SUBJ: Distribution of EPA "NOD/ROD" Notice and "NOD/Availability of ROD" Notice to State of Florida; Tampa Electric Company; EPA EIS for Tampa Electric Company Polk Power Station

PUBLIC NOTICE OF NPDES PERMIT DETERMINATION (NOD)
AND
EIS RECORD OF DECISION (ROD)

Facility Name: Tampa Electric Company, Polk Power Station
Location: Polk County, 9995 SR 37 South, Mulberry, Florida 33860
Permit No.: FL0043869
Permit Effective Date: January 1, 1995
Prior Public Notice No.: 94FL0012; 94FL0016 and 94FL0017
Prior Public Notice Date: February 17, 1994; February 24, 1994
Draft EIS Notice of Availability Date: February 25, 1994
NPDES Permit/EIS Public Hearing Date: March 31, 1994
Final EIS Notice of Availability Date: June 10, 1994
EIS Record of Decision Effective Date: July 14, 1994

TO: Power Plant Siting Review Committee
FROM: Buck Oven *9/13/94*
DATE: September 19, 1994
SUBJECT: Modification of TECO Polk Power Station
PA 92-32A

FIGURE FDOT-1.A.

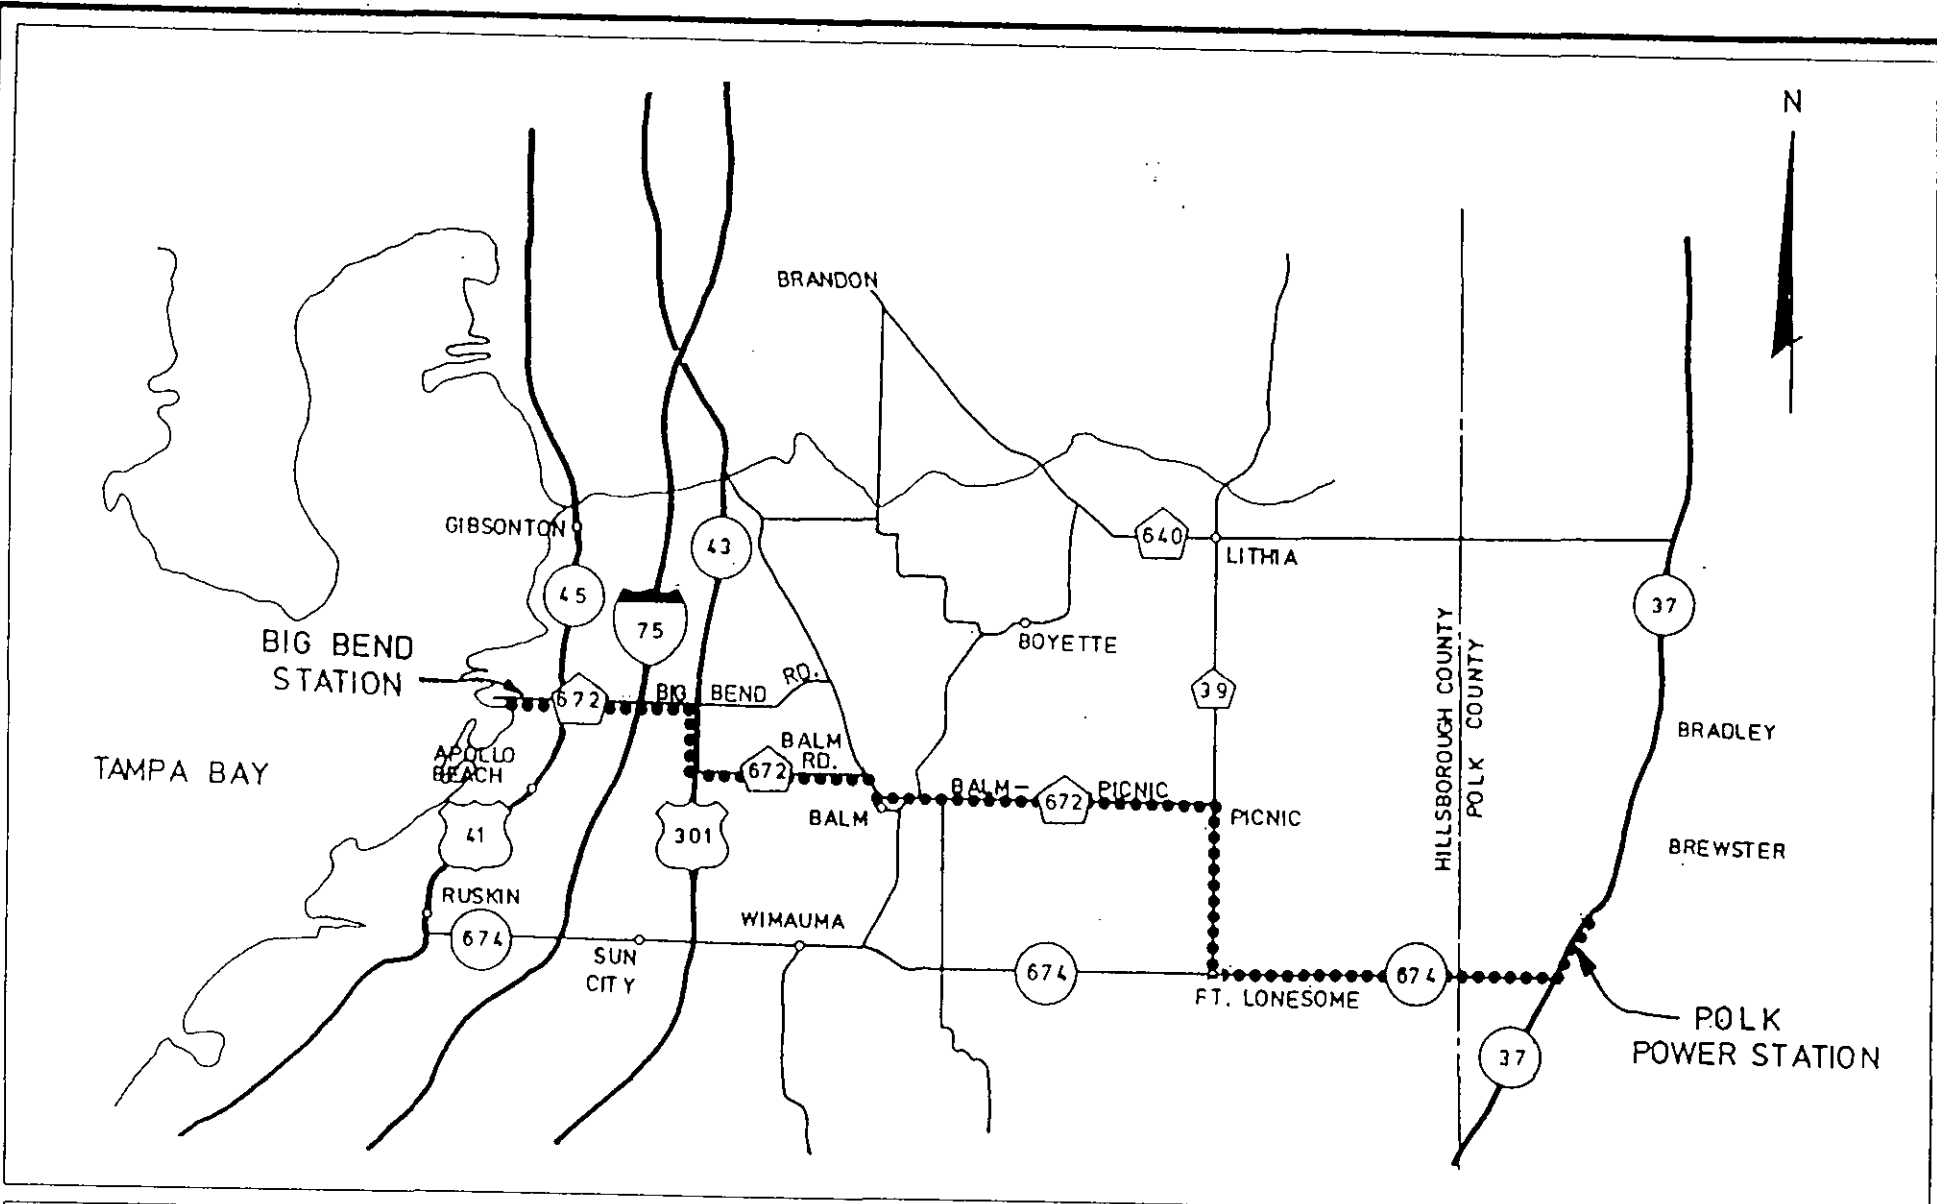
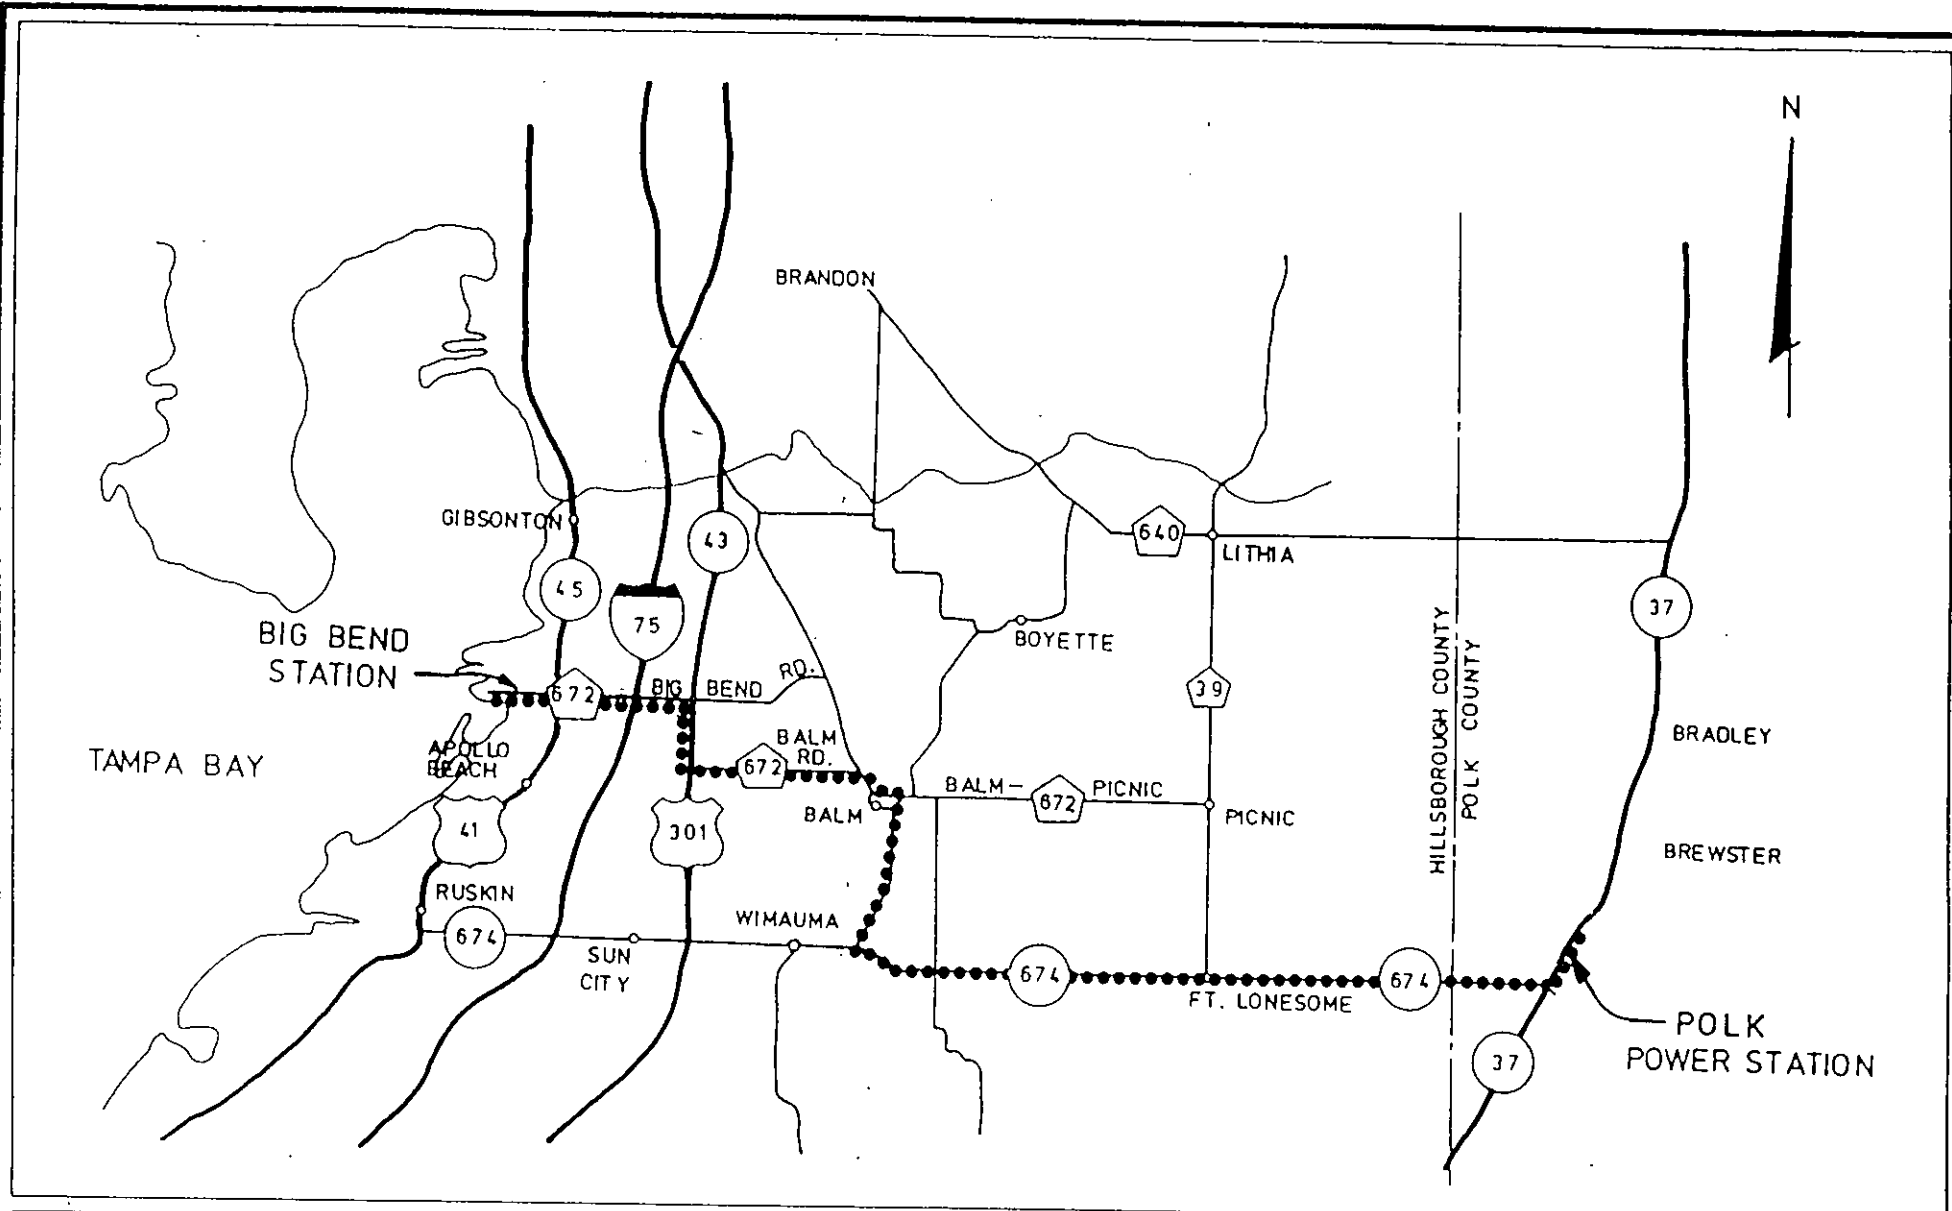
FDOT-2. An analysis on the structural impacts to the haul route, including, but not limited to, State Road 60, State Road 60A, State Road 37 and U.S. 98.

Secondary Route--The secondary route is the same as the primary route except instead of proceeding on Balm Road to CR 39, the trucks will turn right on Balm-Wimauma Road and proceed south to SR 674. The trucks will then turn left on SR 674 and proceed east to SR 37.
